Item 5.**Development Application: 26-30 City Road Chippendale****File No.:** D/2017/1552**Summary**

| Date of Submission: | 10 November 2017 Amended plans submitted 20 April and 31 May 2018 |
| Architect: | DKO Architecture (NSW) Pty Ltd |

Figure 20: A section with the 12 metre standard (in red) and existing buildings illustrated

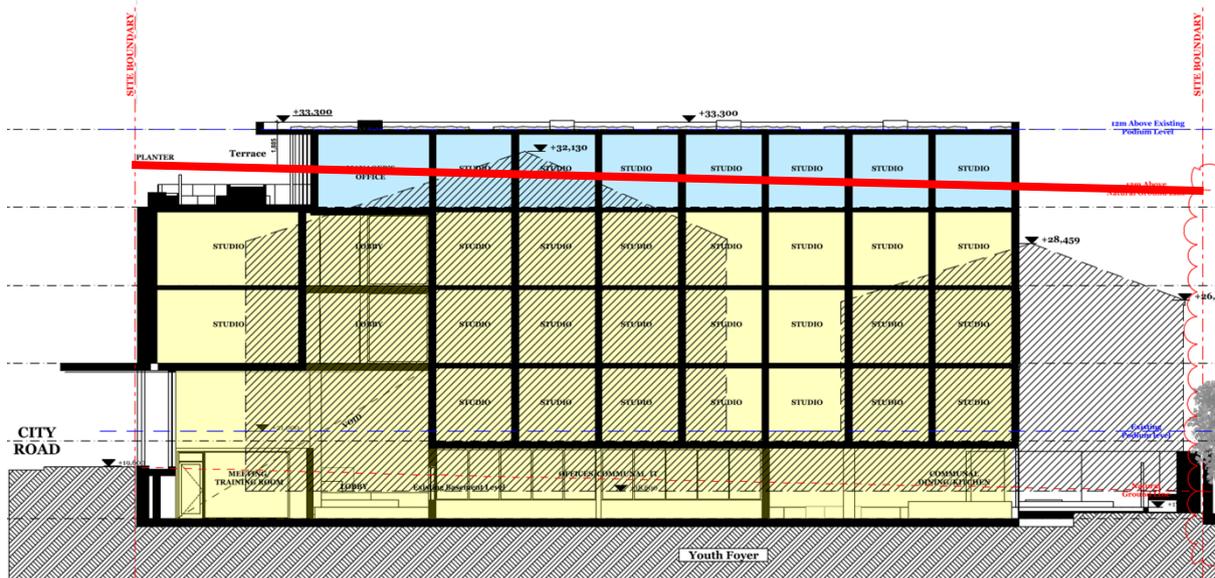
45. The applicant has submitted a request to vary the maximum 12 metre "height of buildings" development standard pursuant to clause 4.6 of the Sydney LEP 2012. The boarding house building will be a maximum height of 15.2 metres to the top of the lift overrun (26.6% over the maximum) and 2.62 metres to the top of the parapet (21.8% over the maximum). Furthermore, at five storeys, the building exceeds the maximum permitted three storey height control under section 4.2.1 of the Sydney DCP 2012.

52. However, the height of the building at the rear does not respond to the condition of the site and its context, in particular the topography and relationship to the terrace dwellings fronting Rose Street. While amendments have been made to relocate an external fire stair to within the envelope of the building, the change does not resolve the sense of overbearing caused by the development on this elevation. Figures 20 and 21 below illustrate these impacts caused by the height non-compliance at the rear of the site. Further discussion regarding overshadowing caused by the proposal is provided below.

Figure 23: The south elevation and the relationship to the adjacent terrace dwellings, with the setback area shown in red.

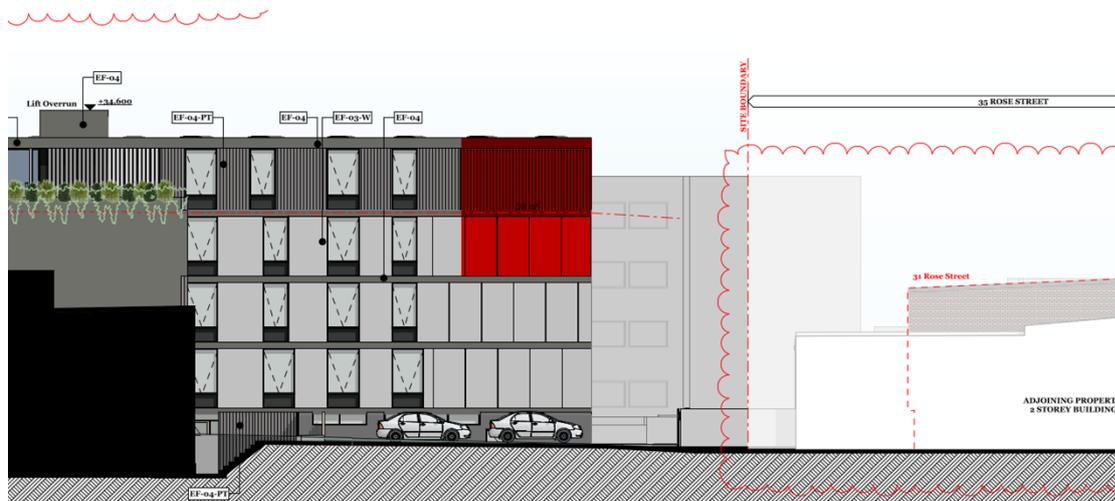
55. Noting that the site slopes from City Road to Rose Street, the existing buildings on site range from two to three storeys and the site is permitted a maximum three storeys pursuant to section 4.2.1 of the Sydney DCP 2012, it is recommended that a transition be provided from five storeys to three by setting back the top two floors of the building at the rear by six metres. Figures 20 and 21 below illustrate the impact of the proposed change, which will result in the loss of approximately eight bedrooms having regard to the relocation of the fire stairs.

56. The applicant has established that strict compliance with the height of buildings standard is both unreasonable and unnecessary, and that there are sufficient environmental planning grounds to support an exception to the standard. Nevertheless, the extent of the exception sought does not adequately address the impacts to neighbouring properties and result in an optimal planning outcome. The proposed design modification to the rear of the building strikes a balance between flexibility and protecting the character of the conservation area and the amenity of neighbouring properties. Through this design modification, the development will satisfy objectives (a) and (b) of the height of buildings development standard, and will result in the development complying with the maximum permissible Floor Space Ratio (refer to discussion below).

Figure 25: Approximate line of the parapet recommended to the roof

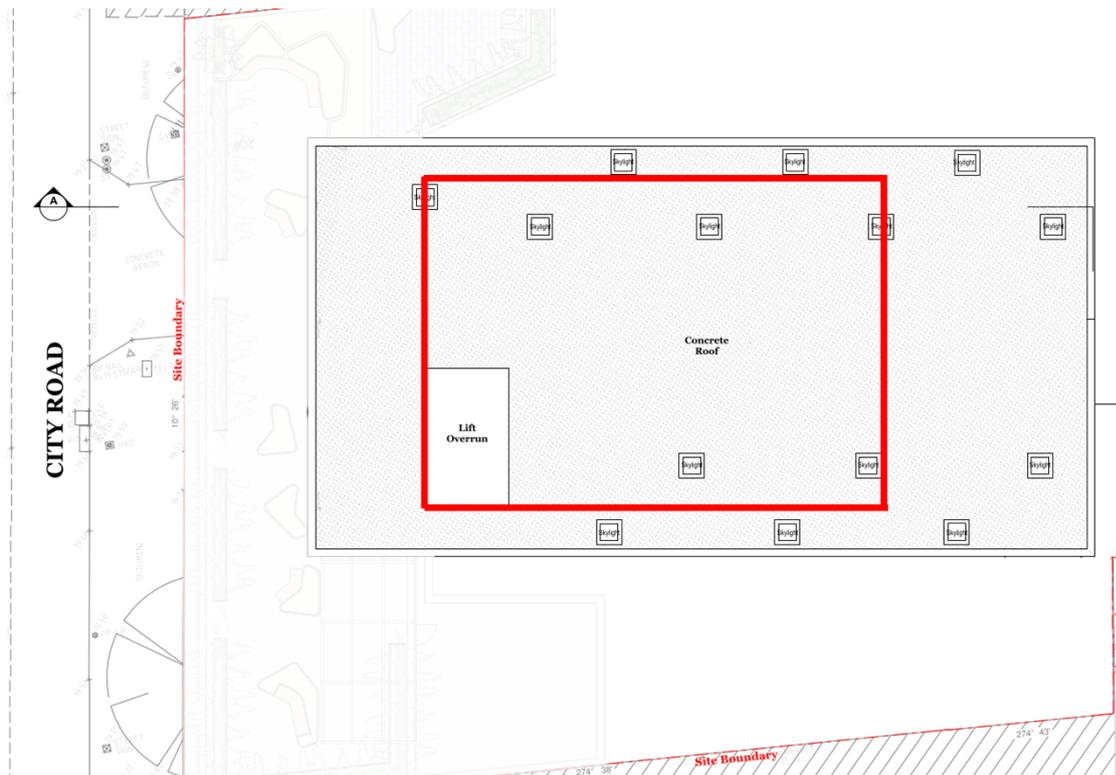
57. With regard to (c) the development will not adversely impact views from neighbouring properties. A continuous masonry parapet set in from the building edge in line with the lift overrun to the same height is to conceal all plant and vents. A condition has been added accordingly.

Figure 27: The area in blue highlights the minimum area required to accommodate 15 motorbikes.

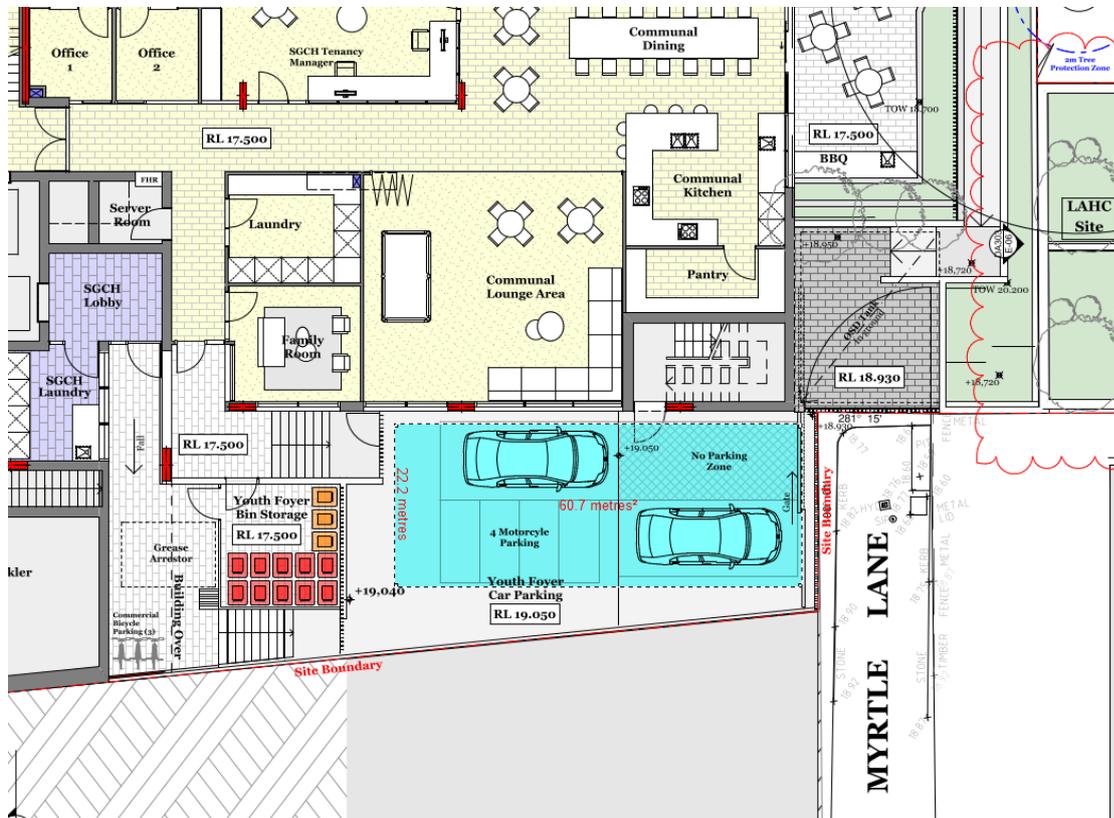
70. The area of the site that would likely be required for the minimum provision of motorbike parking under the SEPP (Affordable Rental Housing) 2009 is shown in figure 27 below, approximately 60sqm. The area displaces the two car spaces and potentially conflicts with the adjacent fire egress. The loss of two car spaces and the potential impacts to the layout of the development in achieving compliance with the standard are unreasonable, particularly with regard to the previous matters raised.

71. Compliance with the motorbike parking standard at Clause 30(1)(h) of the SEPP (Affordable Rental Housing) 2009 is unreasonable and unnecessary in this instance. Sufficient environmental planning grounds exist regarding the accessibility of alternative transport modes and the site's proximity to services, employment, educational and leisure facilities to justify an exception to the standard. The development as amended is compatible with the objectives of the zone, whilst a reduction in the provision of motorbike parking does not conflict with the aims of the SEPP (Affordable Rental Housing) 2009. For these reasons the exception to the standard is in the public interest and is supported.

Figure 28: The rear (west) elevation of the proposed terrace dwellings

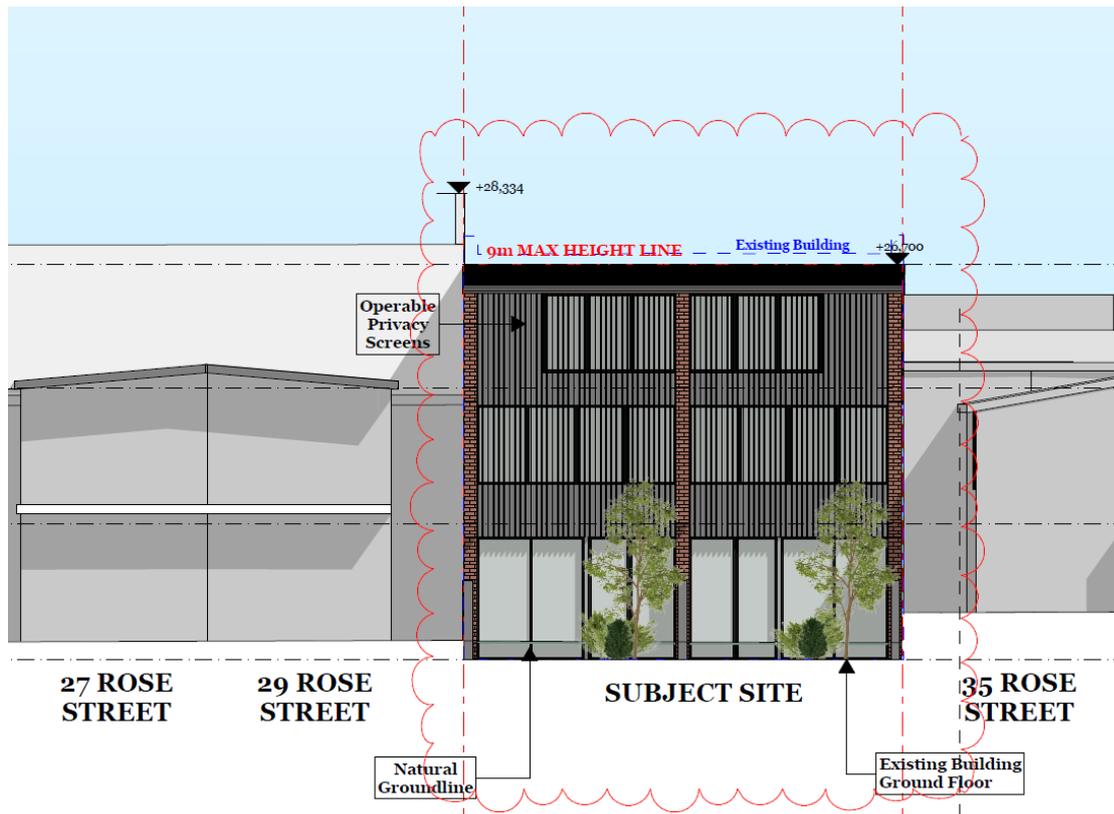
72. The amended plans propose two x three storey terrace dwellings fronting Rose Street. The Rose Street elevation is generally compatible with the form and scale of the adjoining terrace rows and is acceptable. However, the bulk and form at the rear does not conform to the character and scale of surrounding development and is not supported.

76. The three storey, boundary-to-boundary scale at the rear of the proposed terraces does not reflect the pattern of pitched roofs, rear wings and breezeways that characterise the terrace rows adjoining the site. Having regard to the aforementioned controls, it is recommended that the form of the terraces be modified to have a pitched roof and two storey wings in keeping with the pattern of the adjoining terrace rows. The materials and architectural expression are not required copy that of neighbouring properties.

Figure 29: A view from the sun at 11am midwinter. The communal open space is obscured by the tall buildings adjoining the site. The area circled in red is the location of the OSD tank

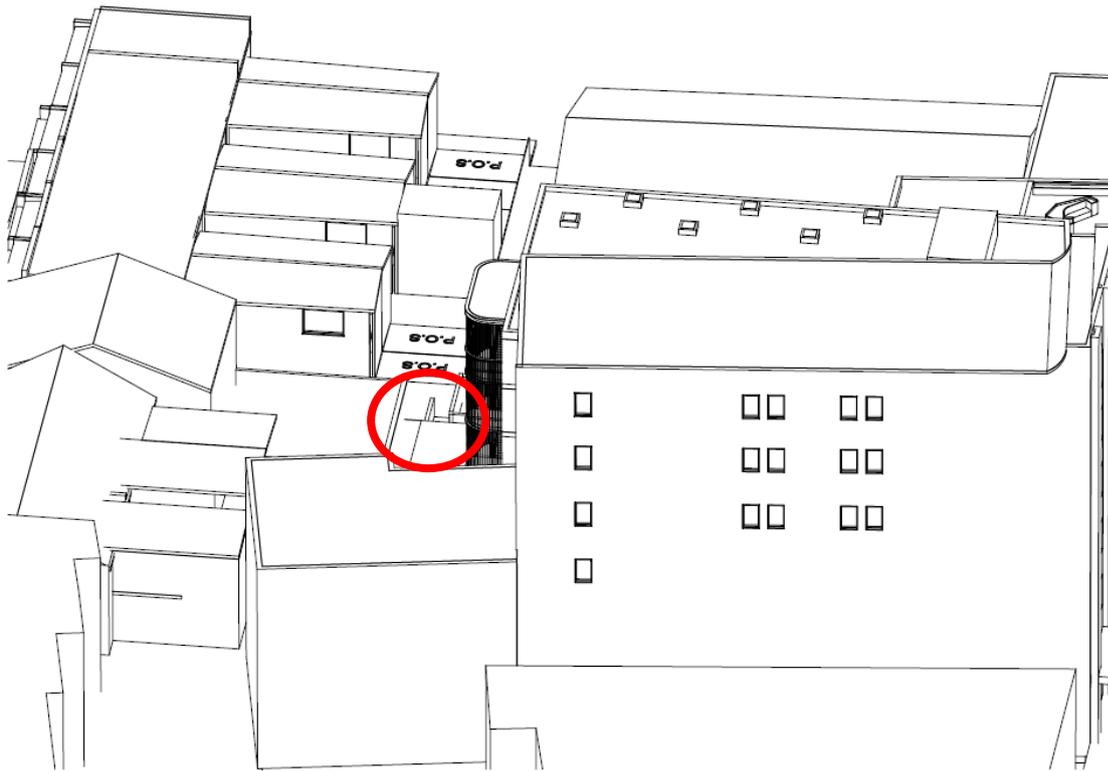
83. Section 4.4.1.4 of the Sydney DCP 2012 requires communal areas, including internal and external spaces, to receive a minimum three hours of solar access during midwinter. While the roof terrace and living area of the SGCH boarding house comply, the communal areas of Foyer51 do not. These spaces are located at the lower ground level and obscured by tall buildings surrounding the site. The figure below is an extract from the applicant's view from the sun diagrams, which have not been updated with the amended plans however still demonstrate the constraints of the site and its context.

84. As previously discussed at paragraph 52, the applicant undertook an exercise in determining the most appropriate built form to maximise the amenity of the boarding houses with adversely impacting the amenity of neighbouring properties. The applicant has decided to elevate the boarding rooms such that solar access and daylight are improved to these spaces, and to ensure physical separation between the facilities of the two boarding houses. The site is also located adjacent to Victoria Park, providing an alternative outdoor area with good solar access.

85. Non-compliance with the control is acceptable in this instance with regard to the constraints of the site and the location of the communal facilities as proposed is the most appropriate location. Subject to design modifications to reduce the bulk at the rear of the boarding house building and the terraces, the design is an appropriate response that achieves the broader aims of providing affordable housing on site without adversely impacting the character and amenity of the surrounding area.
